**Horsham Enterprise Park, Wimblehurst Road, Horsham RH12
Lovells Site (Phase 1 & 2) - Daylight & Sunlight**

Thank you for your recent correspondence regarding Building 3 at the Former Novartis Site. I understand that, following our Daylight & Sunlight Amenity Report dated 12 March 2025, revised plans have been prepared which propose the replacement of the wings of Building 3 (Blocks C11–C15), rather than undertaking structural repair works as previously envisaged.

Design amendments

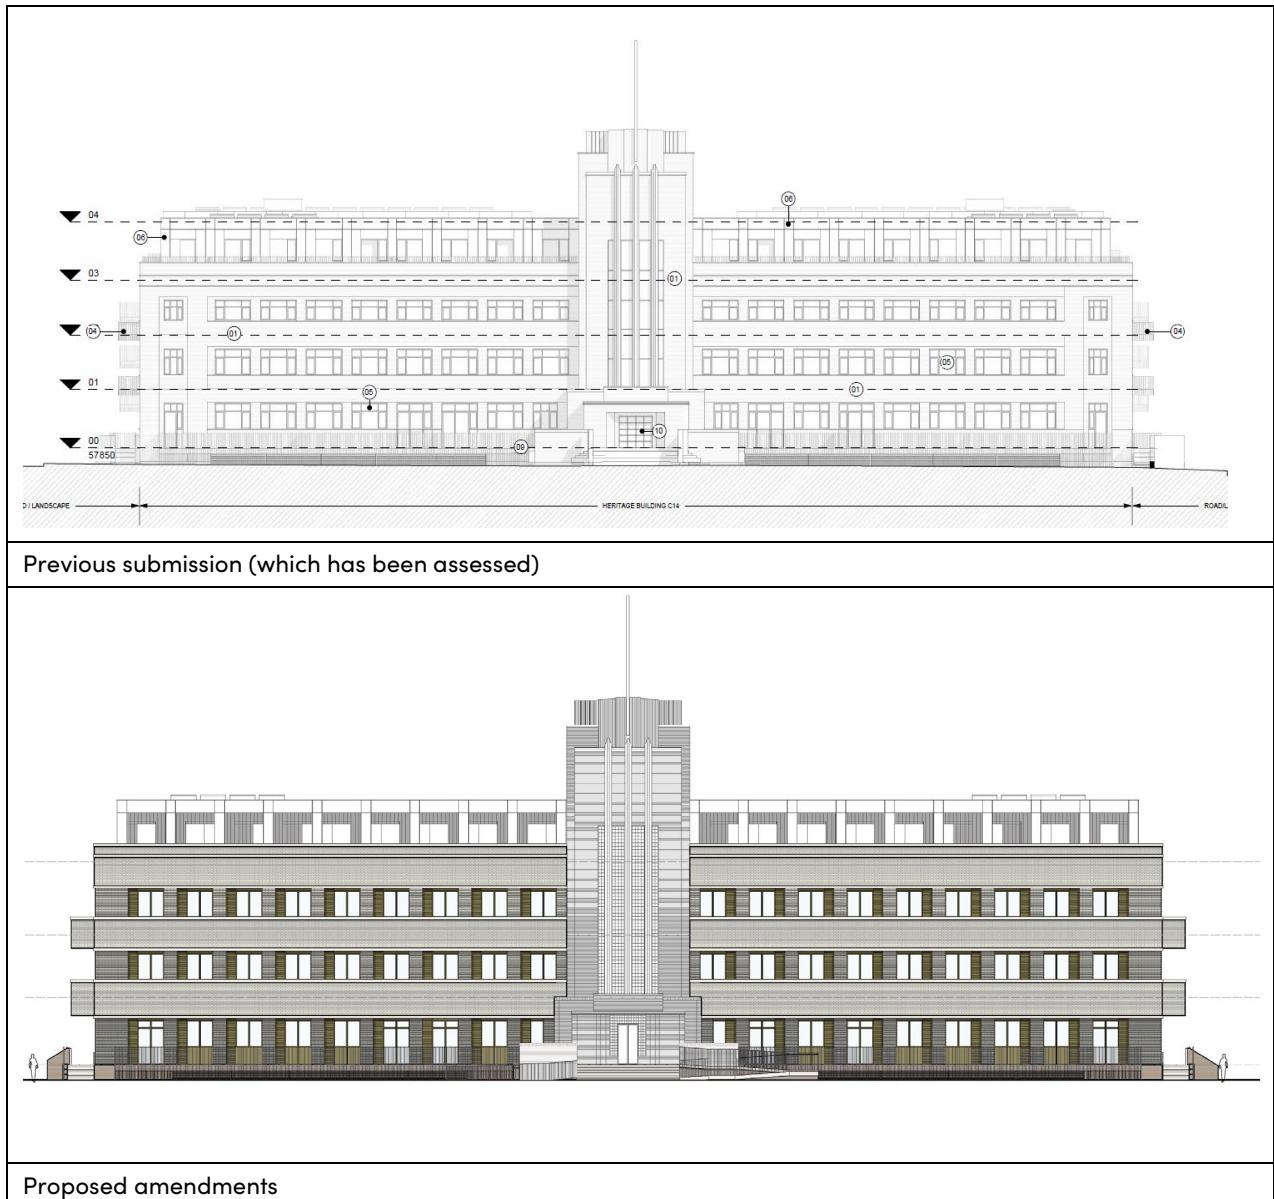
The overall building form and general internal layouts for Blocks C11–C15 remain broadly unaltered from the previously assessed scheme. The main amendments we have identified are as follows:

- Adjustment to the positions of certain balconies.
- Reduction in the width of some window openings compared to the earlier design.
- Introduction of solid external wall panels to balconies, replacing the more open treatments previously shown.

It is clear from the original technical results that the principal daylight to these rooms is provided through their main façade windows, which remain present in the revised design. The recent amendments (i.e., modest reductions in window widths and changes to balcony detailing) are therefore not anticipated to materially alter the results previously recorded.
